September 2011
FL583A
NHTSA #10V-360
Transport Canada #10-258

Subject: Business Class M2 Headlight Height

Models Affected: Specific Freightliner Business Class M2 vehicles manufactured April 12, 2010, through July 16, 2010.

Fig. 1, Headlight Measurement

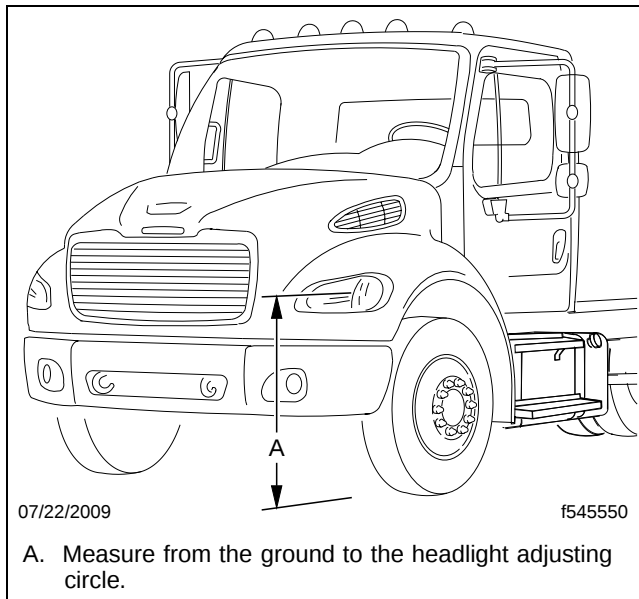
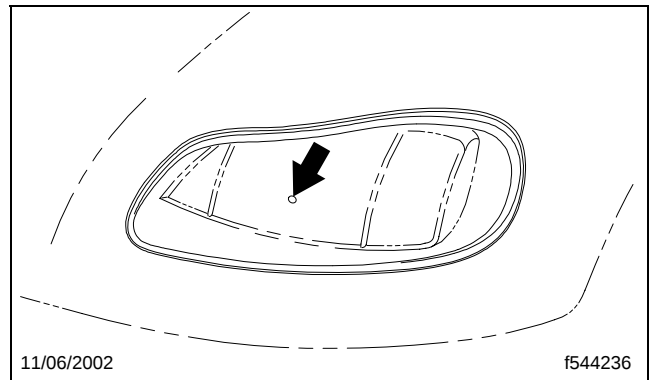
Certain vehicles may have been built with headlights that measure greater than 54 inches above the road surface. FMVSS/CMVSS 108 requires headlights to be not less than 22 inches nor more than 54 inches above the road surface. Improper headlight height may not fully illuminate the road surface or may inhibit the ability of motorists to see vehicles.

- 3.2 Measure from the ground to the center of the highest headlight lens. See **Fig. 1** and **Fig. 2**. If this height is 54 inches (137 cm) or less, nothing more needs to be done. Clean a spot on the base label (Form WAR259) and attach a completion sticker for FL583 (Form WAR260) to the base label.

16. Install the mounting capscrews.
17. Install the headlight cover.
18. Close the hood.
19. Connect the batteries.
20. Check the height of the headlights. Measure from the ground to the center of the highest headlight lens. See **Fig. 1** and **Fig. 2**. The height should be 54 inches (137 cm) or less.

Fig. 5, Securing the Template to the Headlight Opening

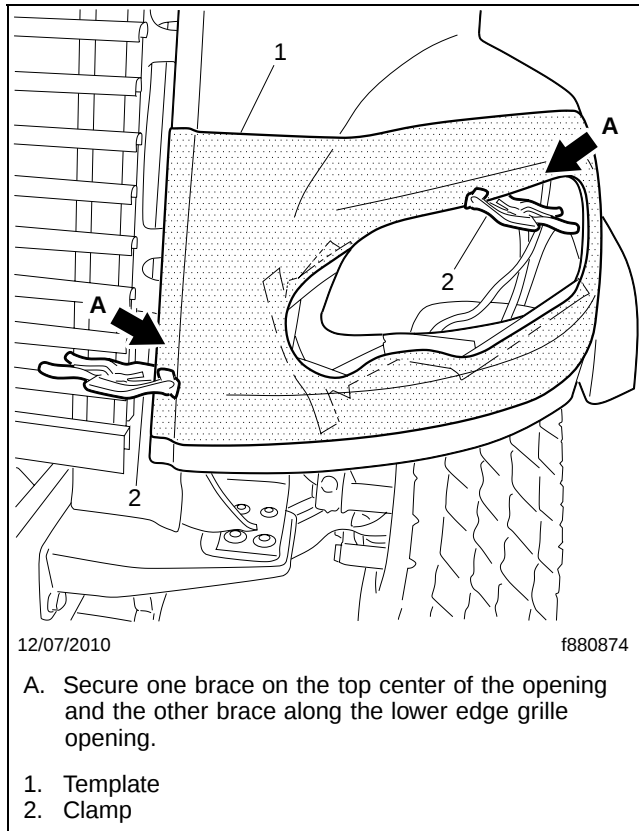
7. If not already done, label both hood templates for use with FL583 and FL592.
8. Position the appropriate template over each headlight assembly and secure it with two clamps. See **Fig. 5**. Secure one clamp on the top center of the opening, and the other clamp along the lower edge of the grille opening.

Fig. 6, Guide Line for the New Headlight Opening

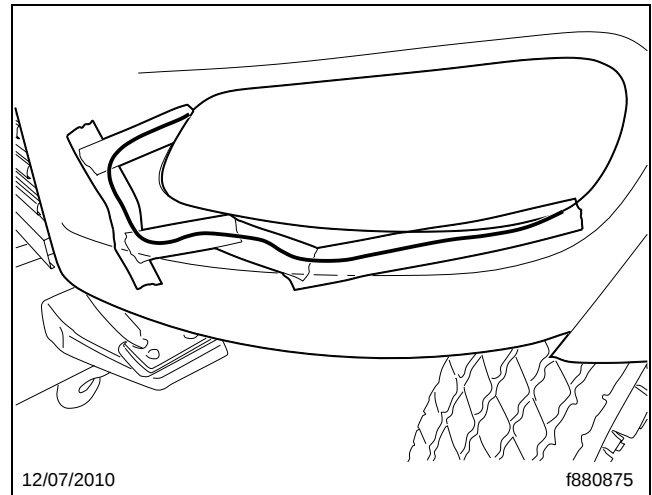
9. Draw an outline on the tape using the edge of the template on each side of the vehicle.
10. Remove the templates. The guide lines for the saw should be clearly visible. See **Fig. 6**.

Fig. 7, Cutting Along the Guide Line

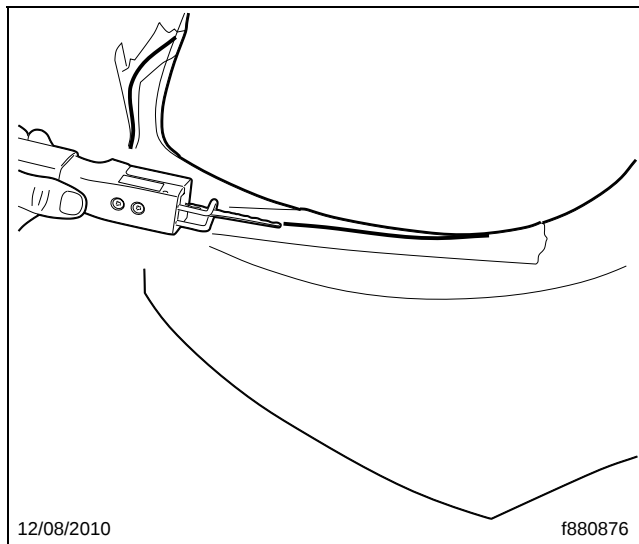
11. Using a metal saw, cut along the guide line. See **Fig. 7**. Use care to adjust the saw and cut around the casting and the wiring support bracket. Repeat on the other side of the vehicle. See **Fig. 8**.

Fig. 9, New Headlight Opening

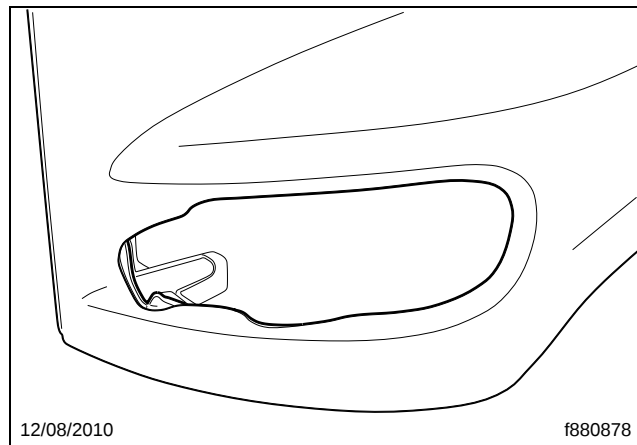
12. Remove the cut pieces of the headlight openings and remove any remaining tape. See **Fig. 9**.
13. Open the hood.
14. Install the new headlight assemblies. See **Fig. 10** and **Fig. 11**.
